# Initial Project Review

## Rezone / Planned Development District / Preliminary Plat / Site Plan Review: Elk Plain Crossing PDD

**Application Numbers: 896267, 896277, 898393, 896281, 896280**

# Open Space and Recreation Plan, revised February 27, 2019

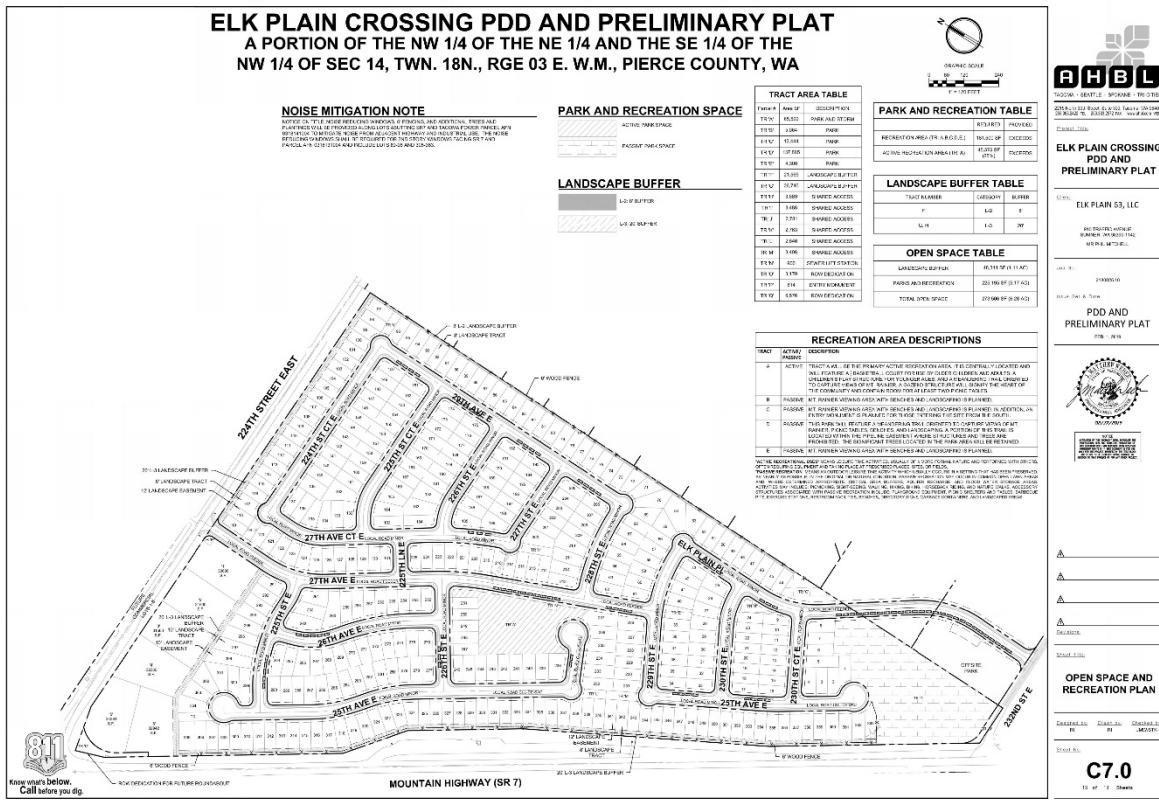
- Recreational Areas (18J.15.180): The 363-lot single-family plat is required to provide 4.16 acres of total recreational area, of which 1.04 acres is required to be dedicated to active recreation, with the remainder at least used for passive recreation. The applicant is proposing a 1.50-acre tract, "A", for active recreation, as well as underground stormwater management. If Planning and Public Works requires an open storm drainage facility the size of the park tract will be reduced. A cluster of three passive recreation tracts, "B", "C", and "E", is located in the southern end of the plat, totaling 0.50 acres. A 3.16-acre passive recreation tract "D" is located at the south end of the plat, which includes a 60-foot wide natural gas pipeline easement, with restrictions on the type of improvements that can be placed over the easement. In addition to on-site recreational improvements, park impact fees, currently \$2,552.39 per dwelling unit, to be adjusted upward for inflation, are required prior to building permit issuance.

## **Grading Plan (North Half), revised March 11, 2019**

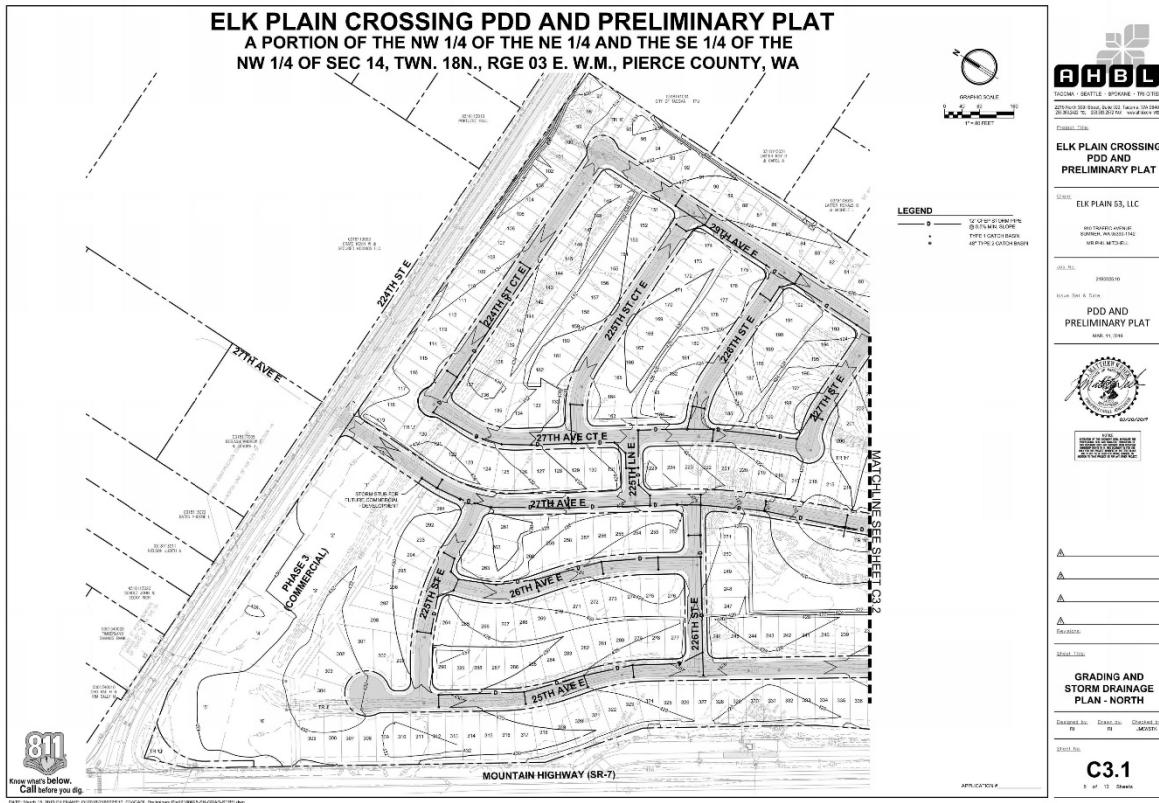
- Site Design (18J.15.015): The former mine site is proposed to be substantially regraded to slope gradually north to south with an approximately 12-foot drop from north to south. The project site is being regraded to closely match perimeter grades in most places but there will be areas of fill slopes up to 6 feet in height along the north, east, and west site boundaries. No slopes are proposed to exceed the 8-foot limit of this section.
- Site Clearing (18J.15.020): The project site is not located in the Pierce County Designated Open Space Corridor so the requirement to preserve a minimum of 15% of the site in native vegetation does not apply.

**Appendix 1. Areas of Forest Types and Sample Plots**

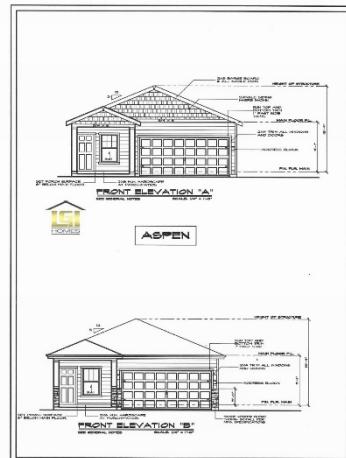
- Tree Conservation (18J.15.030): A preliminary tree conservation plan, dated December 13, 2018, was submitted on February 6, 2019. The plan used forest types and sample plots to determine the following:
  - There are 1,603 trees in the perimeter buffers and internal stands;
  - There are approximately 51 Oregon white oak trees and 34 big-leaf maple trees, all under 6" diameter at breast height (DBH); and
  - There are 378 trees determined to be significant or legacy trees. All these trees are Douglas fir; 112 of the fir trees have a DBH of 40" or greater.

Per Table 18J.15.030-1, a minimum of 30% of trees determined to be significant are required to remain. Based on the estimated total of 378 significant trees, 113 of them are to be retained. Since the applicant is only proposing to retain 20-foot perimeter buffers along SR-7 and 224<sup>th</sup> and 232<sup>nd</sup> Street East and an 8-foot wide buffer along the eastern plat edge, the certified arborist does not recommend retaining only that portion of the existing 100-150 wide existing forest buffers. In the amended report, the arborist recommends that the northern, western, and eastern perimeter buffers not be reduced in width to less than 40 feet to tree health and minimize tree fall danger on new homes.

Since maintaining perimeter forest buffers of a minimum of 40 feet in width would significantly reduce the number of proposed lots, the amended tree conservation plan proposes to preserve 25 (6.6%) of the 378 significant trees south of the natural gas line and 25 significant trees on a proposed off-site park to the east. The applicant has requested Site Plan Review (SPR) to reduce the number of significant trees to be retained from 30% to 6.6% along with 25 significant trees to the east. All significant trees would be Douglas fir. In addition, the arborist feels that some of the estimated 51 Oregon white oak trees could be relocated to parks within the plat and to landscaped areas in the commercial shopping center, along with the addition of Oregon white oak nursery stock as additional mitigation.
